SONY® Service Bulletin

NO: ME3-99-010

SUBJECT: ROTARY ENCODER VOLUME MAY NOT WORK

MODEL (S): MDX-C670/C7900/C8900

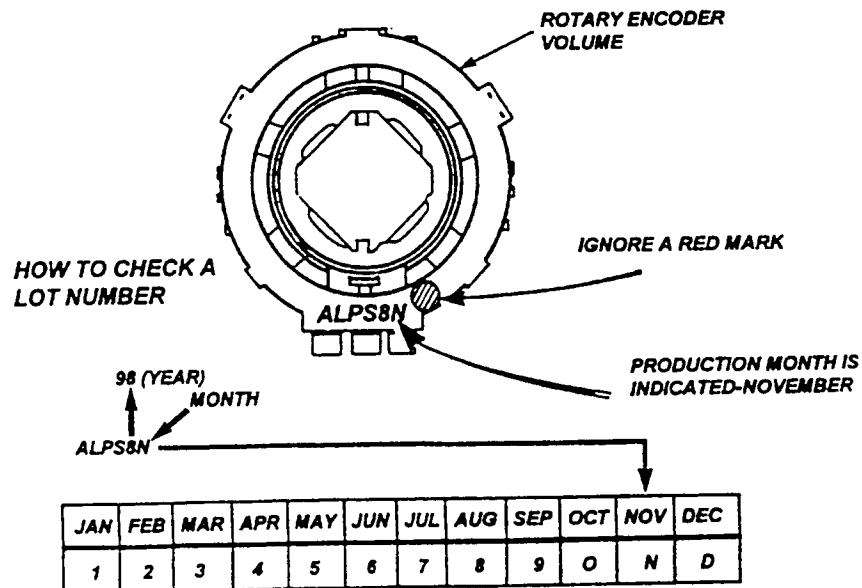
SYMPTOM: The operating volume may not be adjusted, or randomly changes. This may be caused by contact failure of rotary encoder that adjusts volume.

SOLUTION: If this condition exists or customer complaint is this symptom then, replace the rotary encoder with an improved one. Please indicate what month and year the encoder was manufactured. All encoders produced before November 1998 are subject to failure.

Please use illustration to verify lot number.

DESCRIPTION	PART NUMBER
ROTARY ENCODER	1-475-014-12
